Complaint Id : 595097

GULMOHAR RESIDENCY

Details of Additions & Alterations

Flat No	307	Block no.	' C '
Flat Area	1660 sft	Type	Deluxe / Luxury
Buyer Name	Raji Reddy		
Phone No.	9666711110	Email

Changes in kitchen platform: (mark on plan)

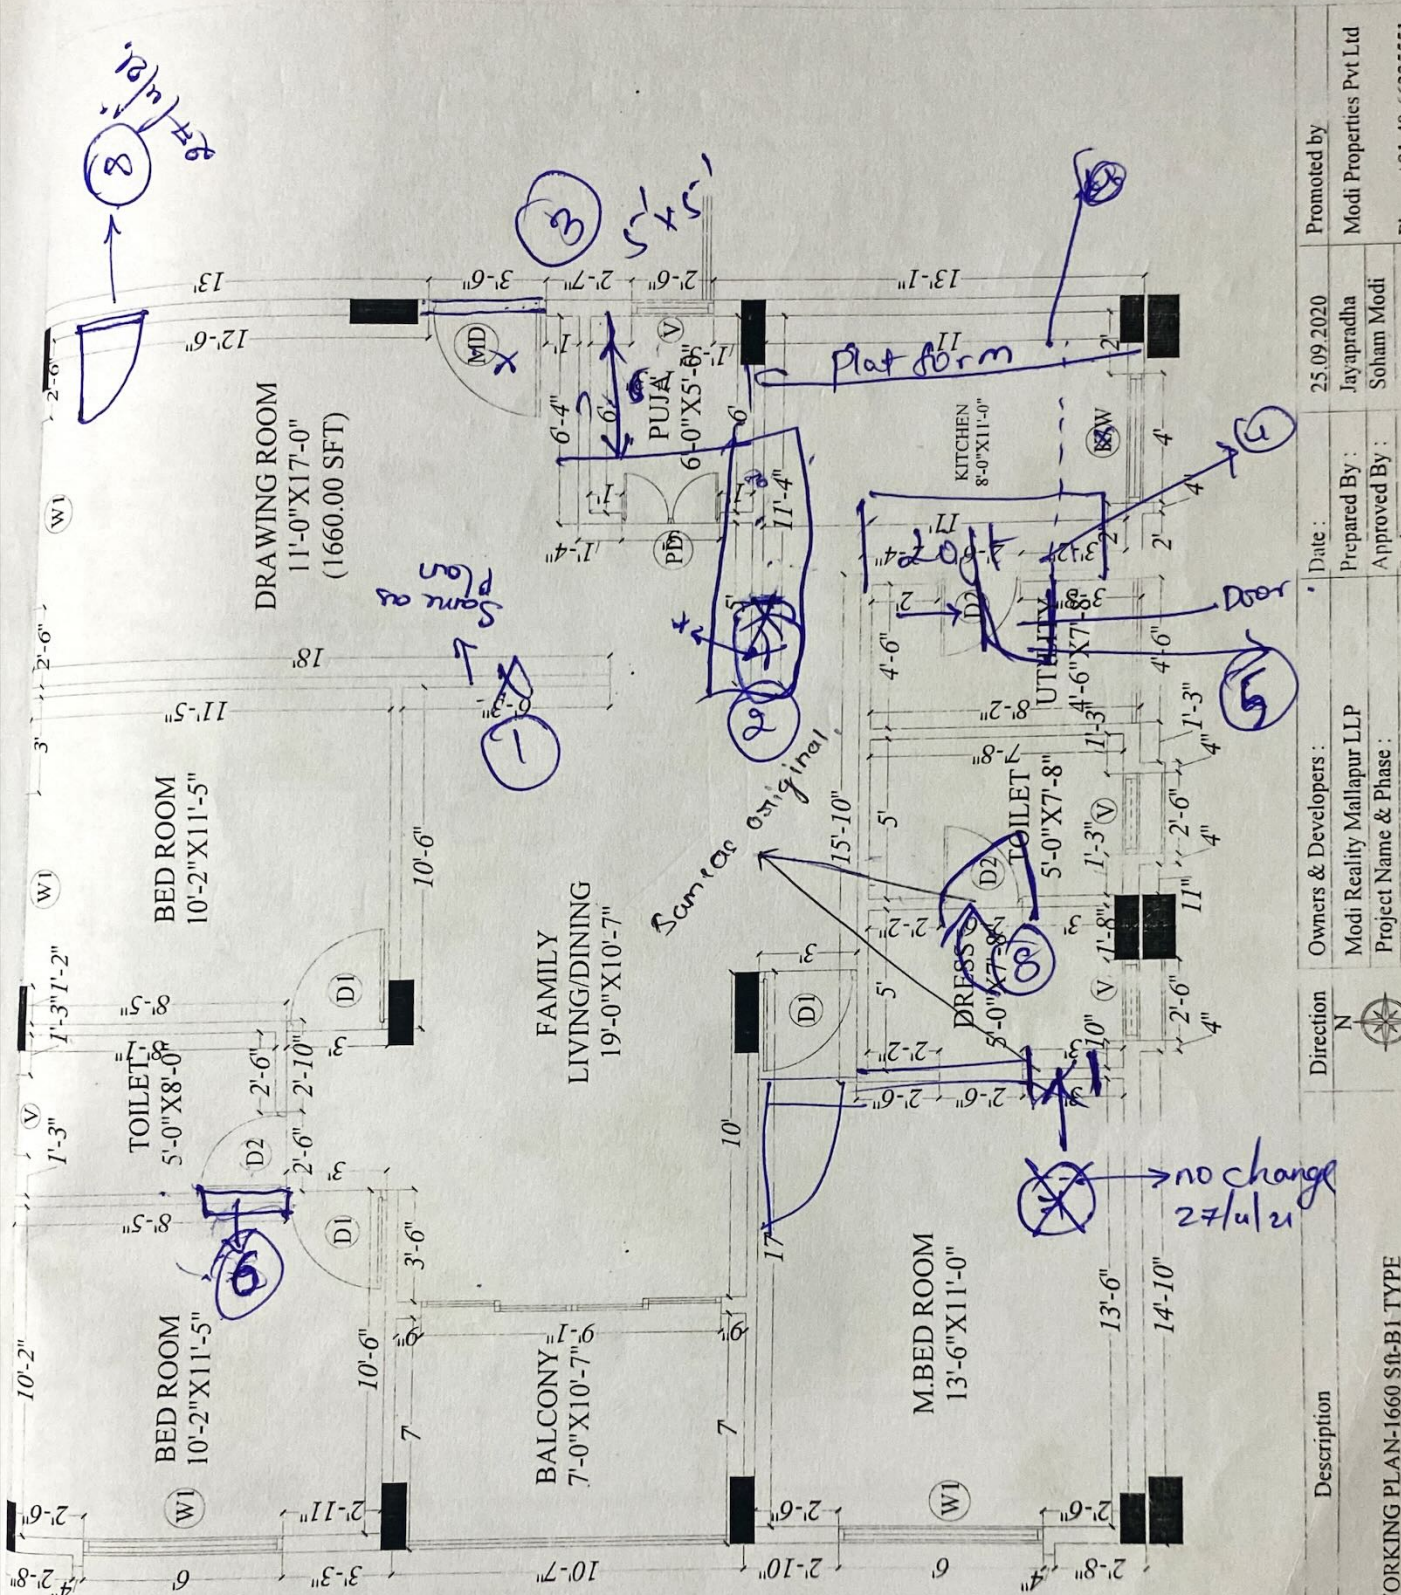
① Modular. by customer.

Description	Direction	Owners & Developers :	Date :	Promoted by
WORKING PLAN-1660 SIBI TYPE	N 	Modi Reality Mallapur LLP Project Name & Phase :	25.09.2020 Prepared By : Jayapratha Approved By : Soham Modi	Modi Properties Pvt Ltd

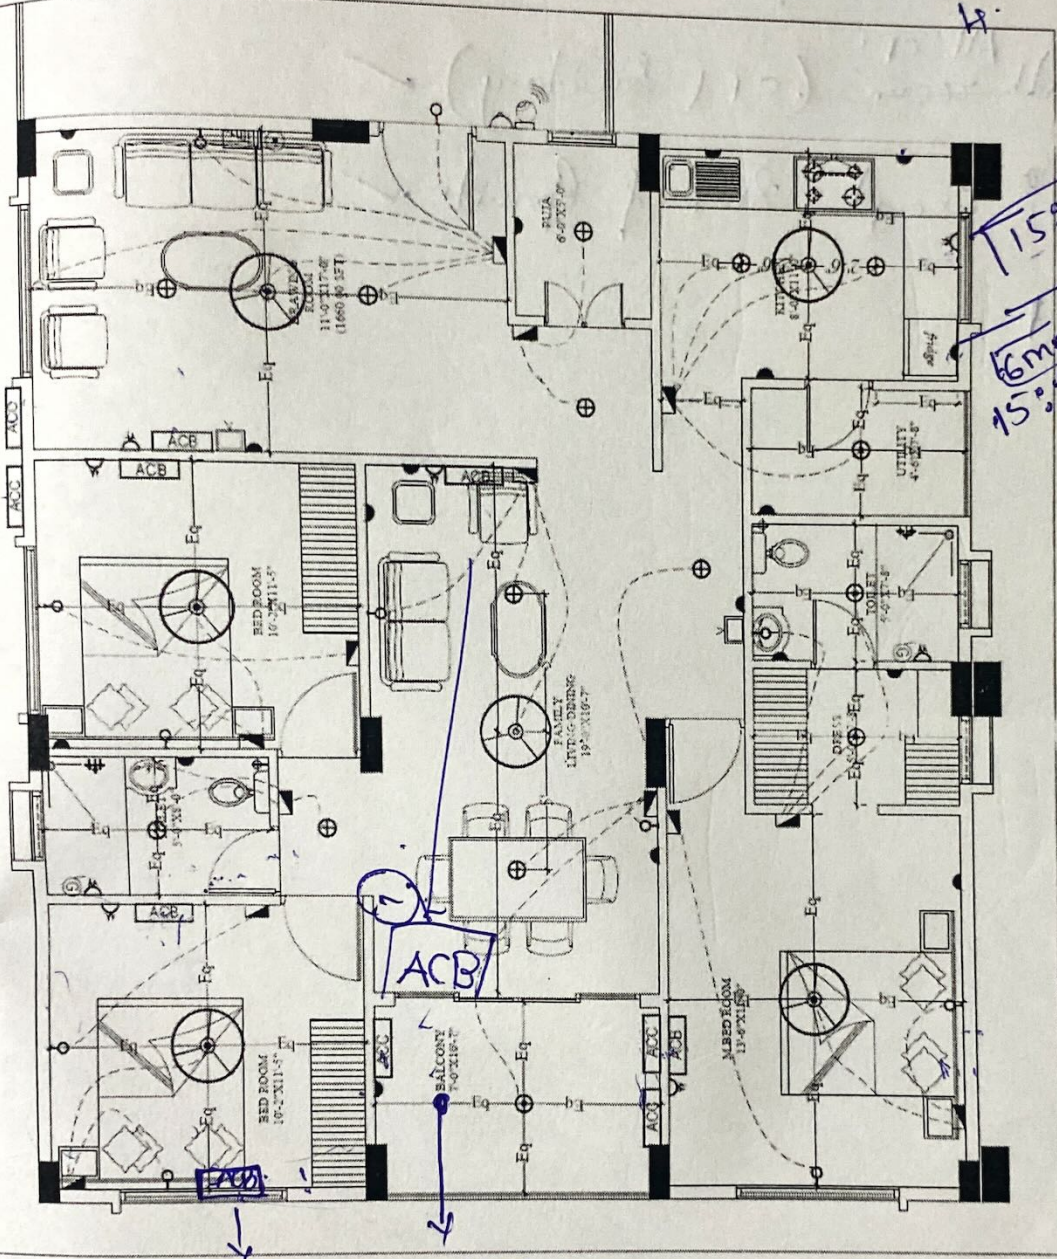
Utility door frame size should be 3x6'
Shift: M.D Position.
